SiteCheck AI — Inspection Report

Ruleset: IS456 | Units: metric

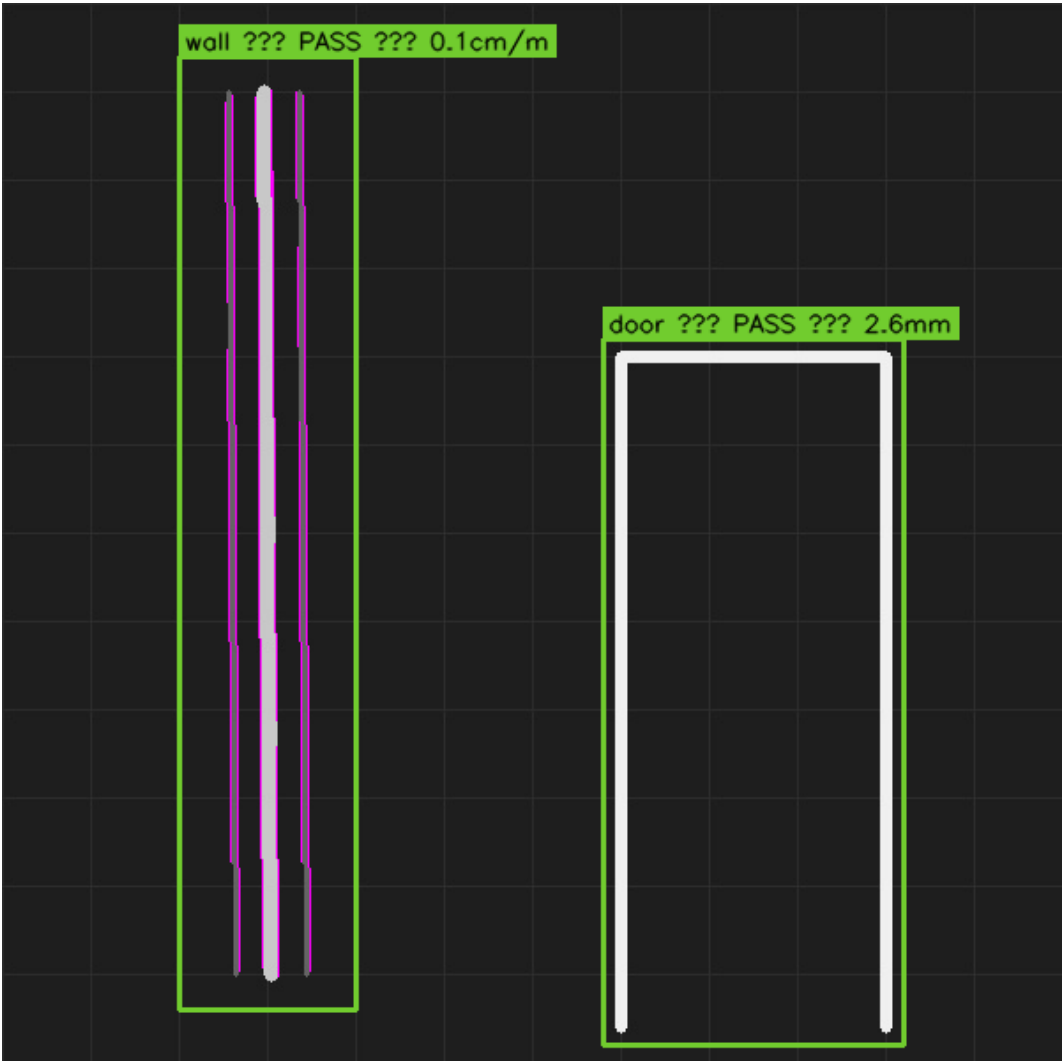
- wall failed check: wall: vertical deviation 6.26 cm/m (3.6° from plumb).

- Re-capture photo for wall — measurement inconclusive.
- Rectify wall deviation before proceeding.
- Review door: Door frame gap asymmetry ≈ 29.8 mm.

- case2_wall_plumb_uncalibrated.jpg — 1 elements
- Photo may be too dark — consider re-uploading with better lighting.

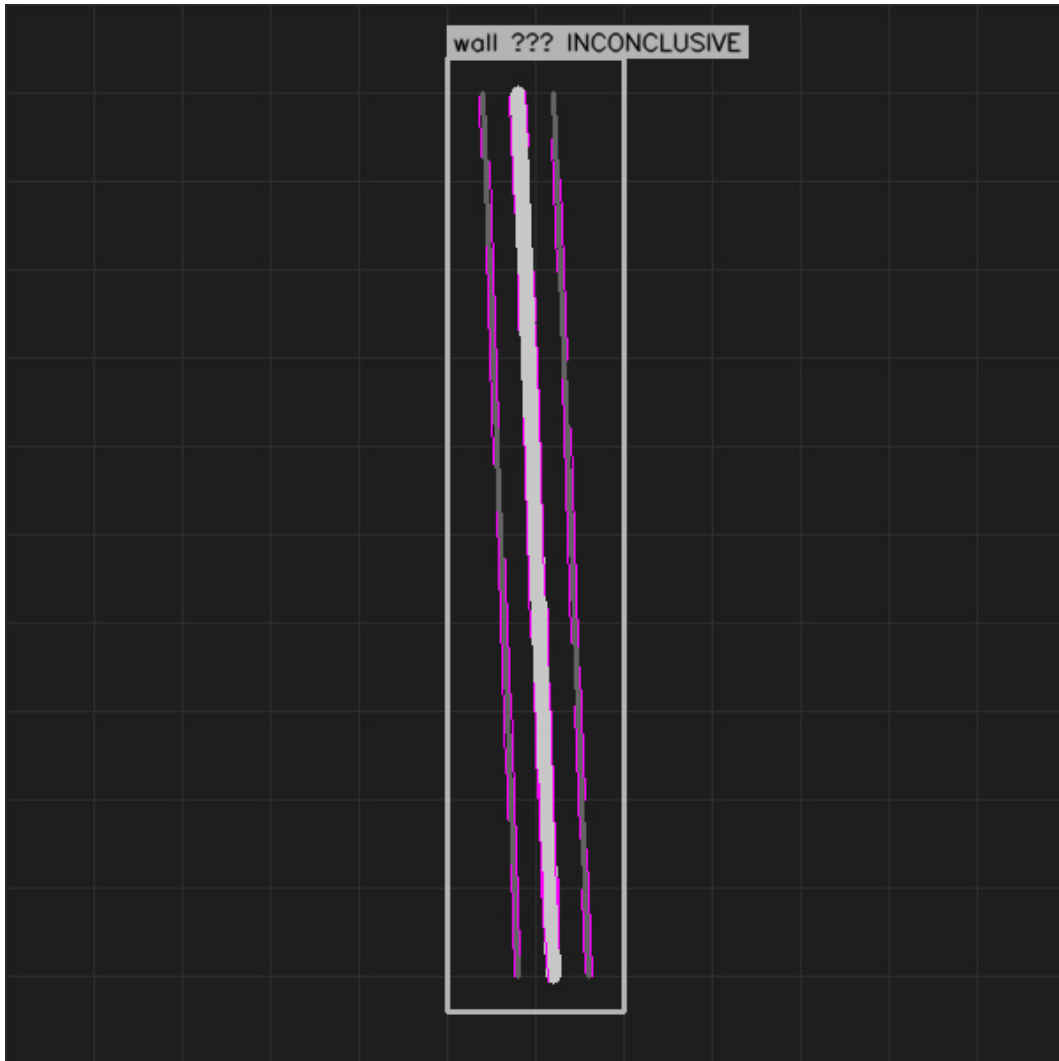
- Photo appears blurry — measurements may be unreliable.
